TO: Khadeja Sarwar, Atwell, LLC
FROM: Amber Wood Hicken, Planner I
DATE: 4/9/25
SUBJECT: Parker Pointe, Black Rock Coffee, Site Plan
Review Comments 02

BLACK ROCK COFFEE BAR
 13135 DECLAN DRIVE
BLACK ROCK COFFEE BAR
 SITE PLAN

BLACK ROCK COFFEE
MODULAR BUILDING

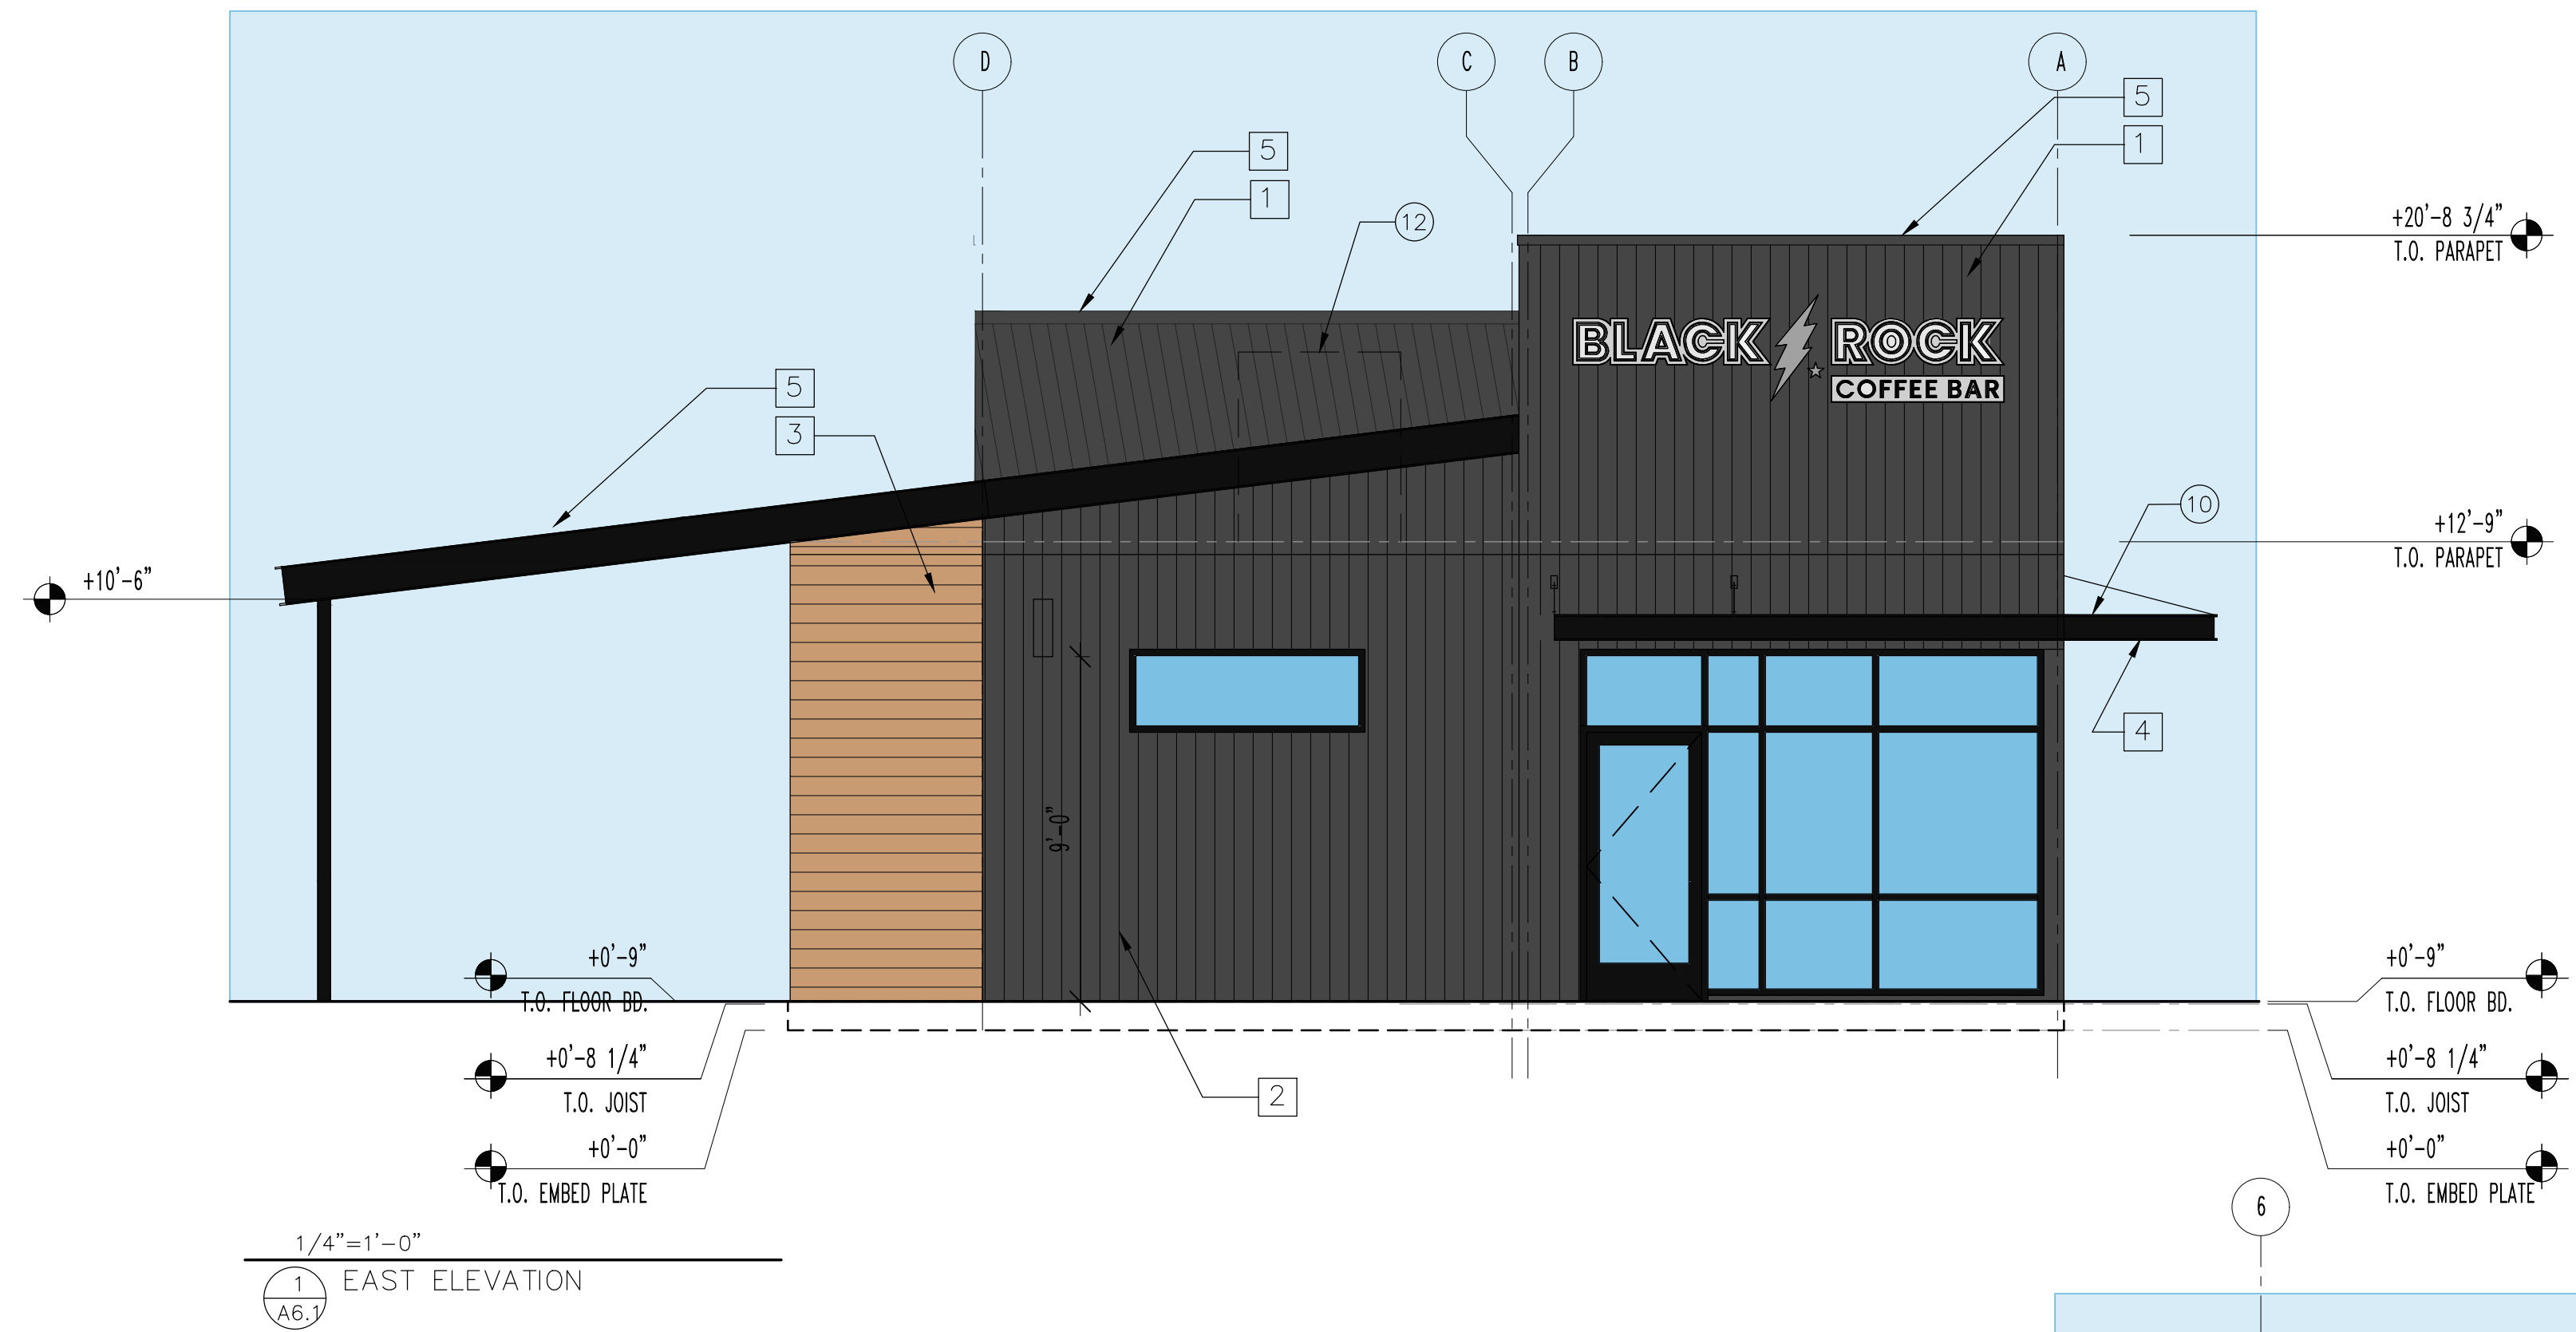
#13 electric meter not shown. please show on elevations, add note that it will be painted to match adjacent wall

#14 screen wall not shown. this should be shown on elevations and site plan.

architecture needs to be enhanced. only two materials used on entire building - add more materials, possible corner feature on parker road, etc.

what is this portion? wall? please label, show on all relevant elevations.
